TECHNICAL NOTE			
from:	ALAN DAVIES	date:	15/8/022
subject:	Technical Details Consent for proposed residential development of upto 9 dwellings following Permission in Principle application 3/2018/0582 south of Old Road Chatburn 3/2022/0500	file ref:	J1050-TN2

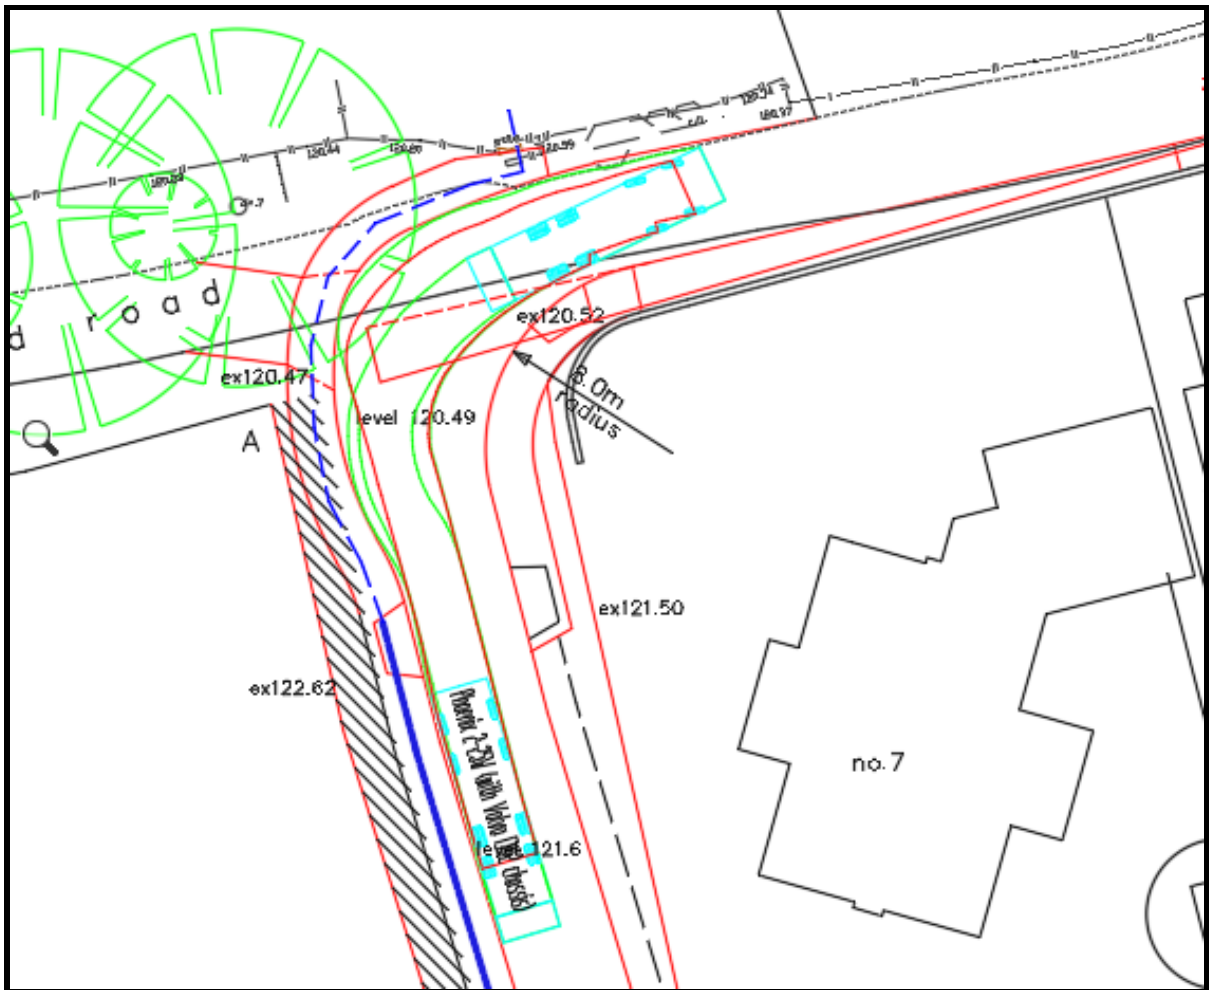
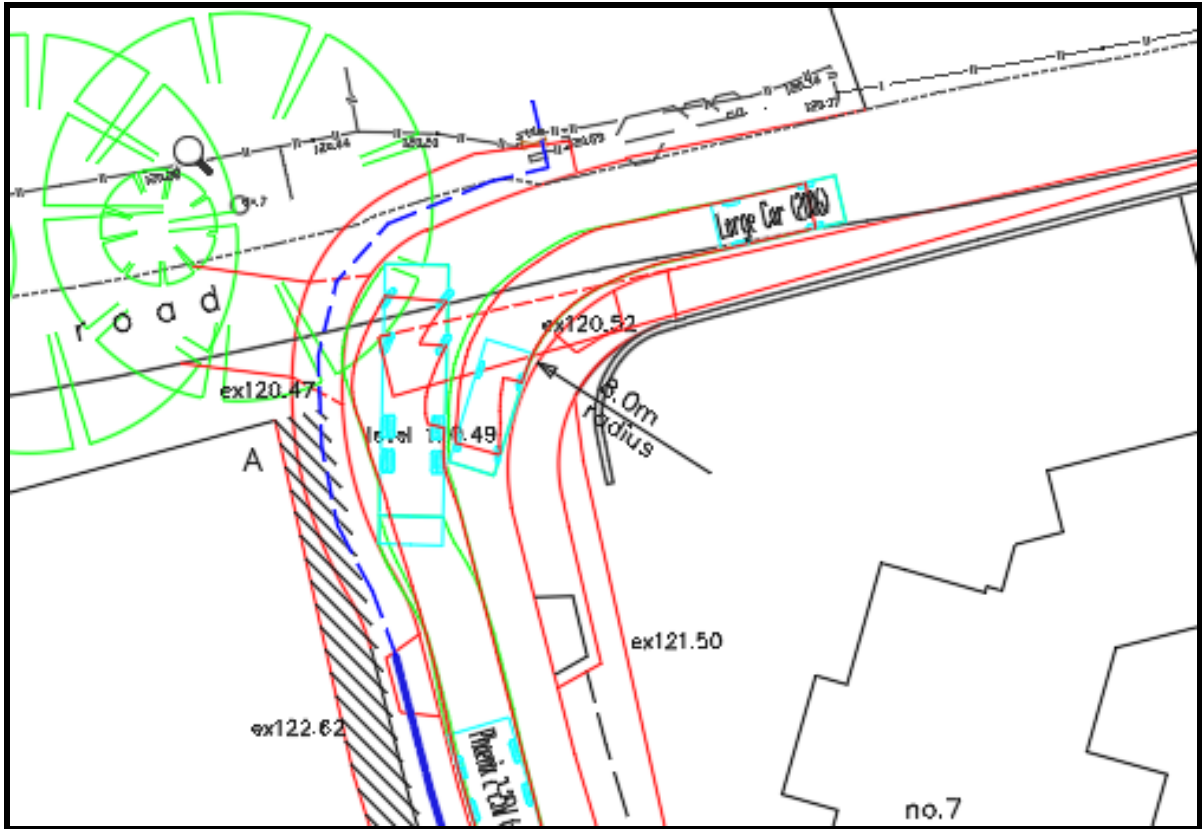
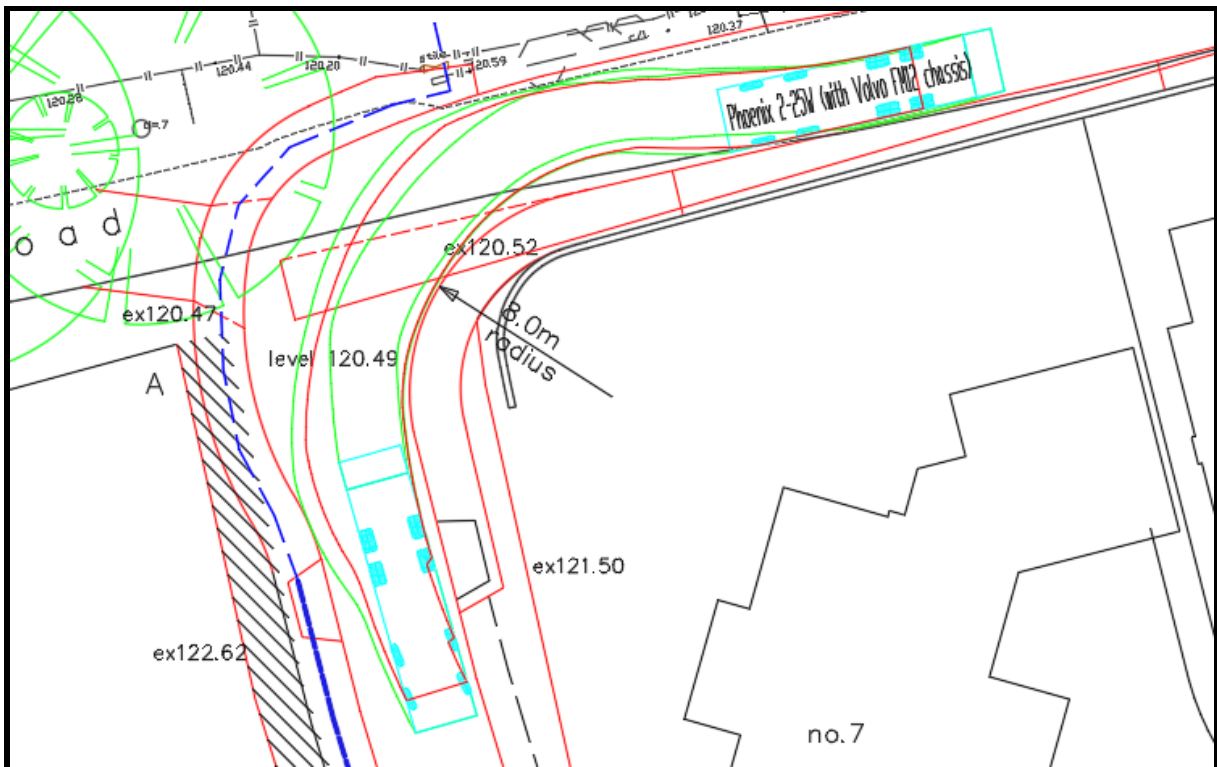
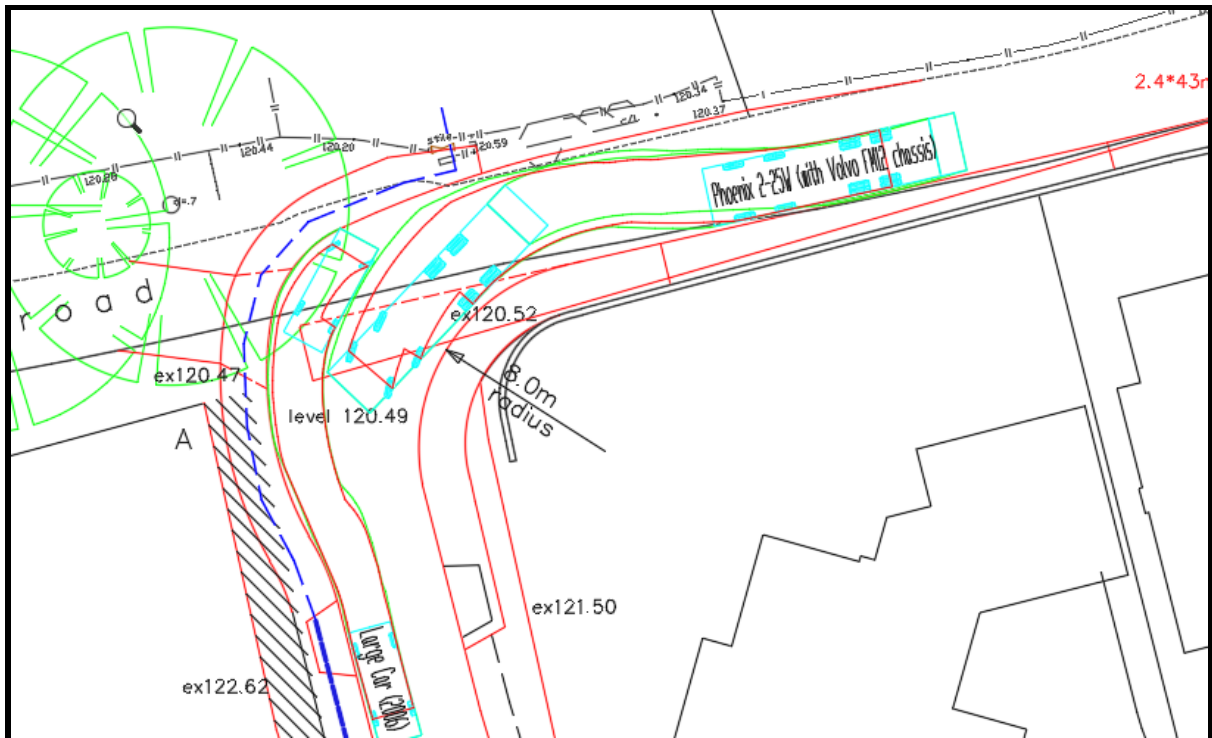
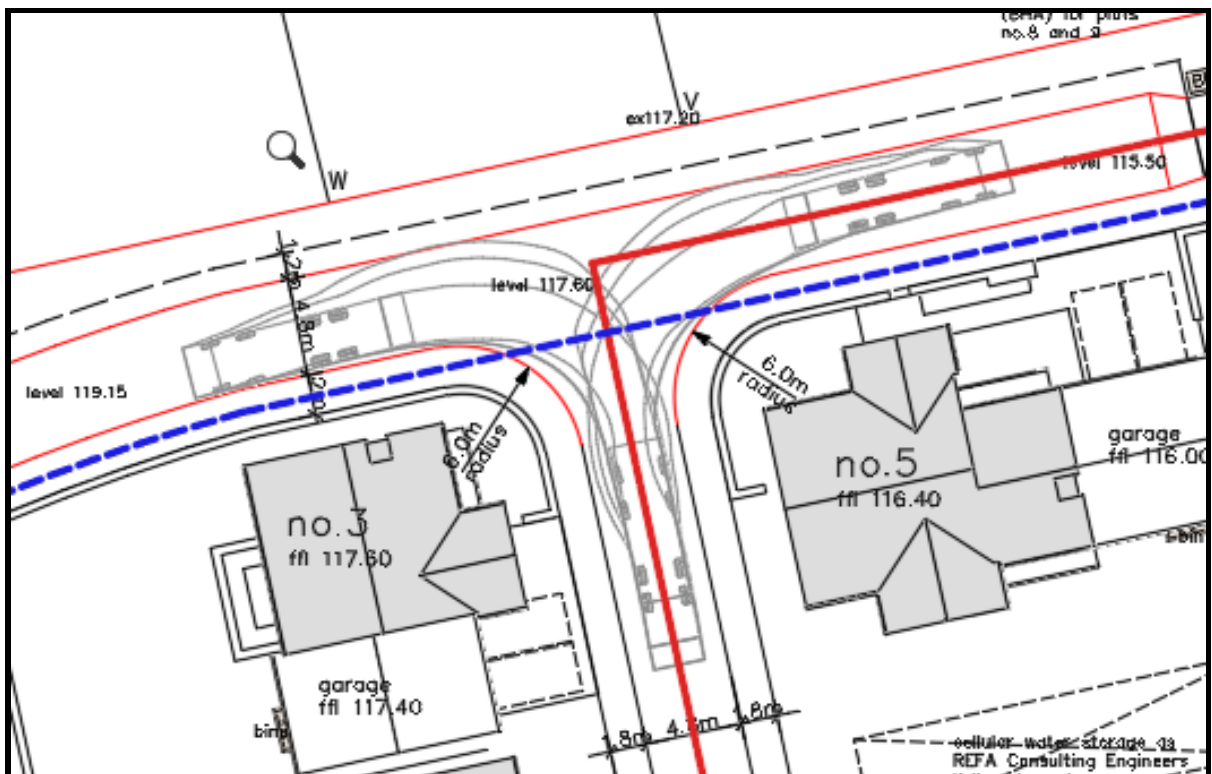
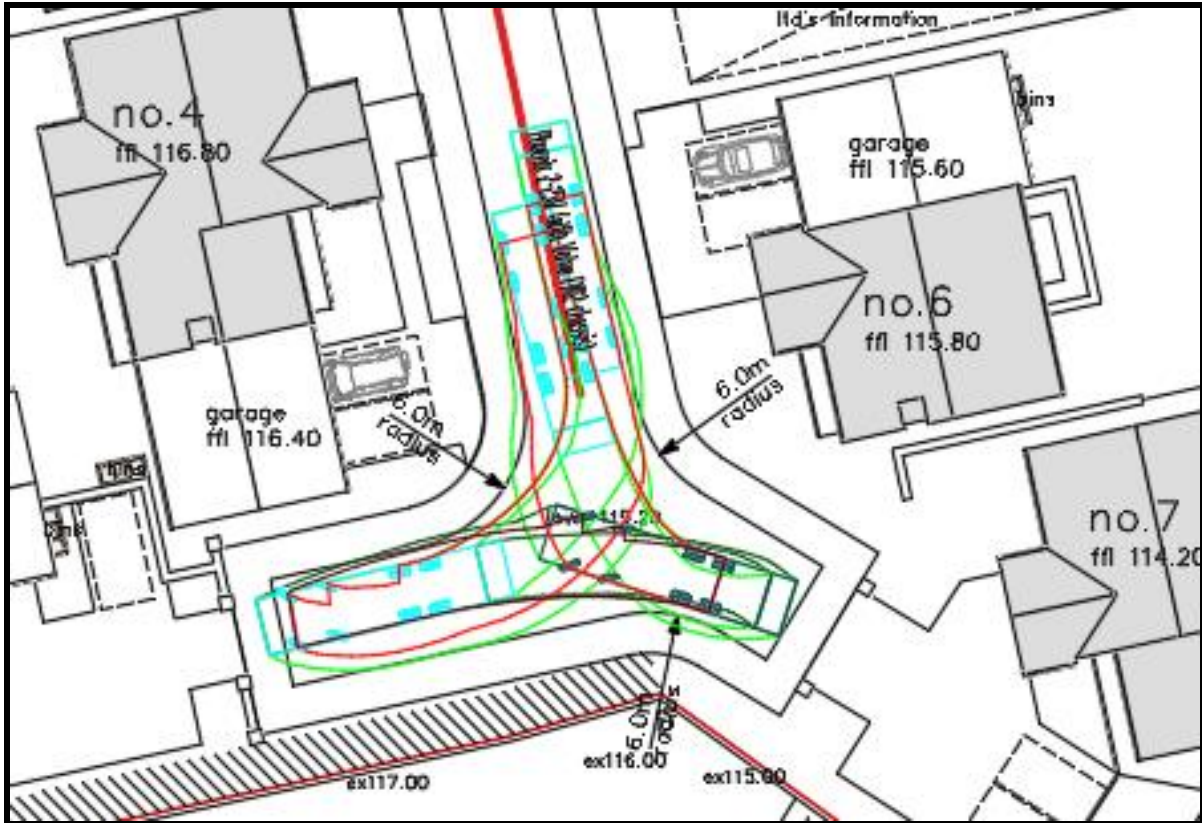
The LHA have reviewed Stanton Andrews drawing number PL30 Rev A titled "Proposed Site Plan" and are aware that the proposed access will have a kerb radii of 6m and 9m. To ensure the kerb radii is adequate for refuse vehicles a swept path analysis drawing is required showing the refuse vehicle entering and exiting the site.

The swept path analysis drawing will also allow the LHA to assess whether the access width is adequate for two-movements to occur when a large vehicle is using the access.

To ensure that the minimum width of the carriageway and the layout is adequate, a swept path analysis drawing showing a refuse vehicle using the internal layout is required. The drawing should also show how the refuse vehicle will use the turning head to exit the site in a forward gear.

The need for large vehicle access is understood however it has to be noted they are low in number i.e. refuse 1 per week, deliveries worst case 1 per day average thus the norm is car/car in/out.

Overleaf is two cars in/out with no overlap. It is a free flow junction does not give way, the stub end of the road is some 35m and leads to quarry boundary.

The approved Hares Hill Croft phase 1 used a smaller refuse vehicle for access/approval as such this assessment is very much worse case.

Below out for refuse, bend flared to accommodate turn.

HGV out and car in can pass each other.

HGV in with overturn.

HGV in and car can pass each other

Three point turn at T junction and overleaf forward gear in/out of turning head

See above swept paths.

The above is based on a T junction rather than freeflow, that said sight line of 43m to right and 35m to left shown. Full details DTPC J1050 access layout and PROW fig 1

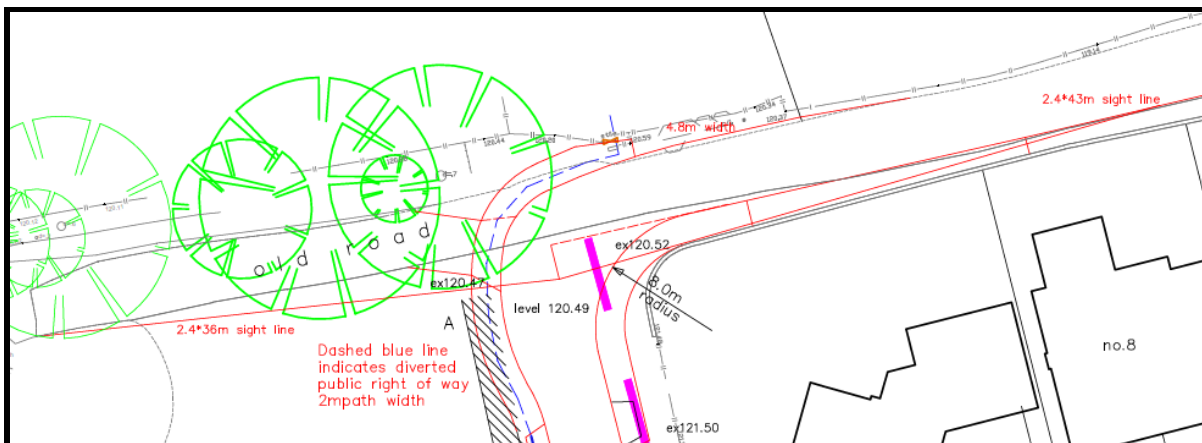
Furthermore, the LHA require a drawing showing that the access can provide visibility splays of 2.4m x 43m to the right of the access. Usually, the LHA would require the visibility splays to show 2.4m x 43m in both directions, but the LHA are aware that the highway ends approximately 35m to the left of the access. Therefore, the LHA will accept the maximum visibility the access can provide to the left of the access

Drawing DTPC J1050 Mitigation TRO fig 1 and abstract below shows initial reply to the request to enable consultation to take place on the scheme options.

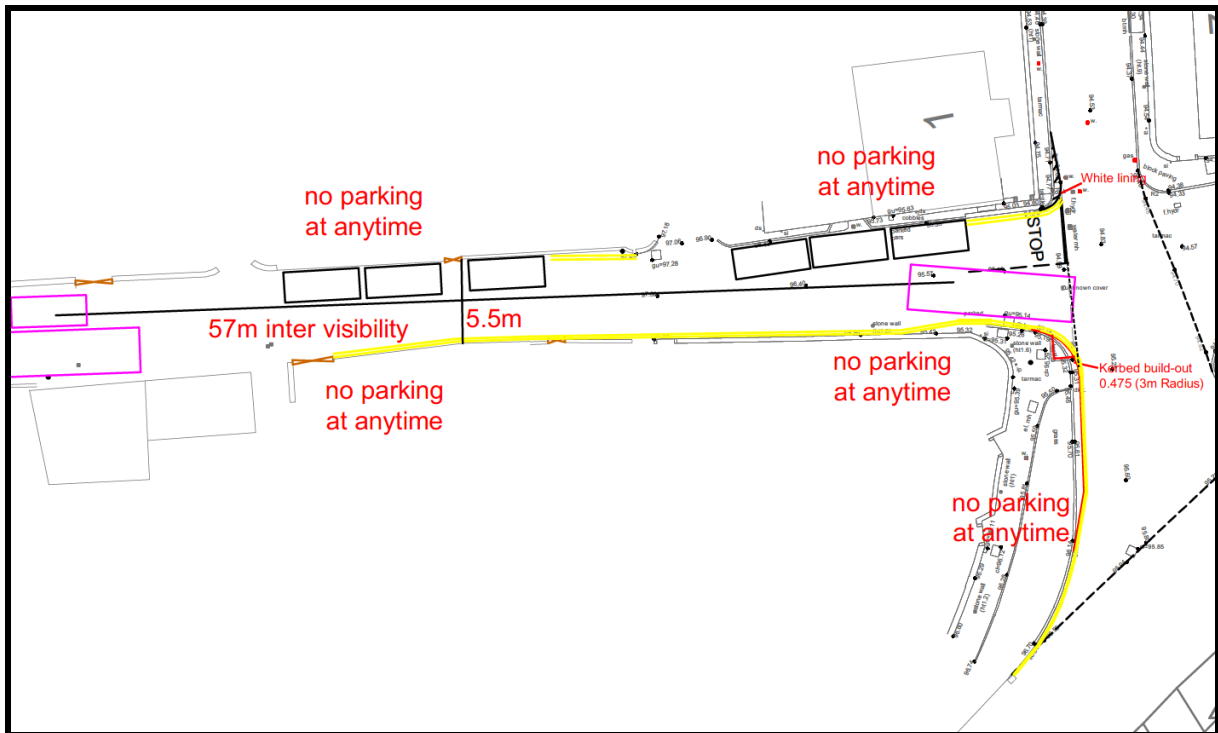
The LHA will request that a number of Traffic Regulation Orders (TRO) are provided at the junction between Crow Trees Brow and Ribble Lane; junction between Ribble Lane and Chatburn Old Road; and along Chatburn Old Road.

The LHA inform the reader that these requirements are subject to change, following agreements with the LHAs Traffic team and following a public consultation where the locations of these TROs will be identified. But these requests are required for highway safety reasons.

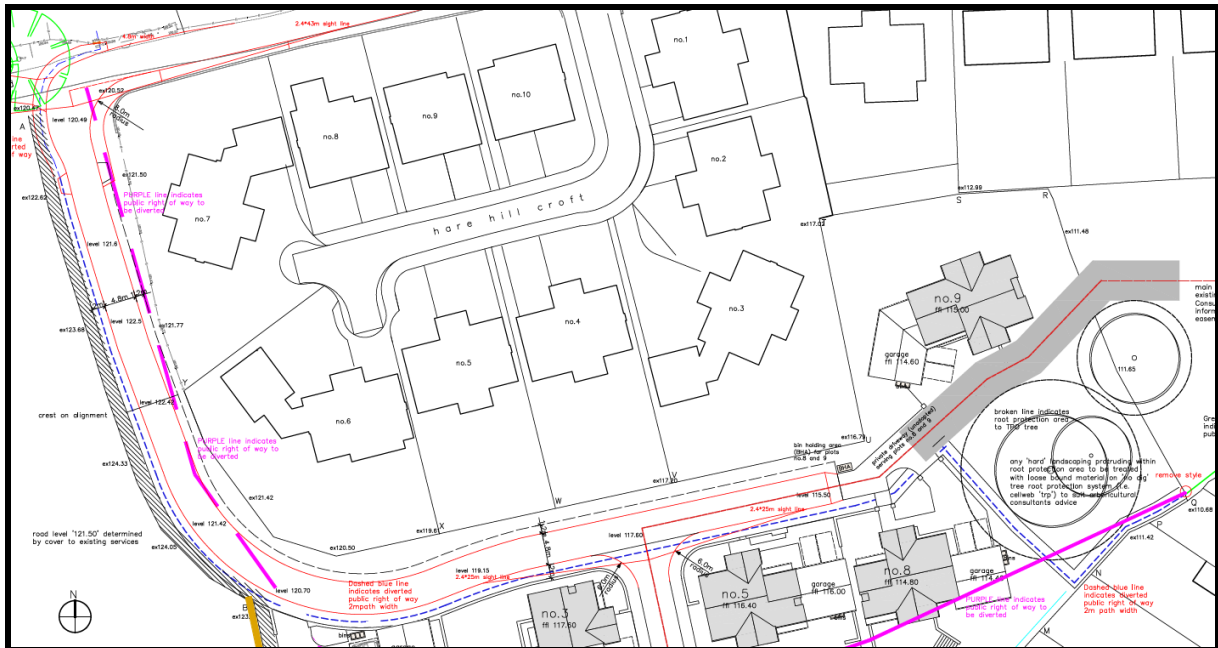
Lancashire County Council — Public Rights of Way have identified that **3-11-FP1** runs through the proposed development site and that the site is subject to an application to add a length of public footpath to the Definitive Map of Public Rights of Way. The Proposed Site Plan **PL30** highlights that the recorded digitised line of footpath **3-11-FP1** is affected by several properties and no provision has been provided for the DMMO should it be Confirmed

The abstract below shown in purple the current alignment of the footpath created as part of the 1971 stopping/diversion order. It links from the green section between the hedge/fence linking back to Crowtrees Brow. To the north it connects across Old Chatburn Road and continues the path as FP 14.

For absolute clarity the DMMO application made by the local residents is subject to legal review and objections, an objection on behalf of the landowner has been lodged.

The process is one where if an order is made by LCC it is subject or will be subject to an appeal and additional legal scrutiny, it currently has no standing for the application as submitted and if the application is approved with the diversion as set out below it will no doubt require review and possible updating.
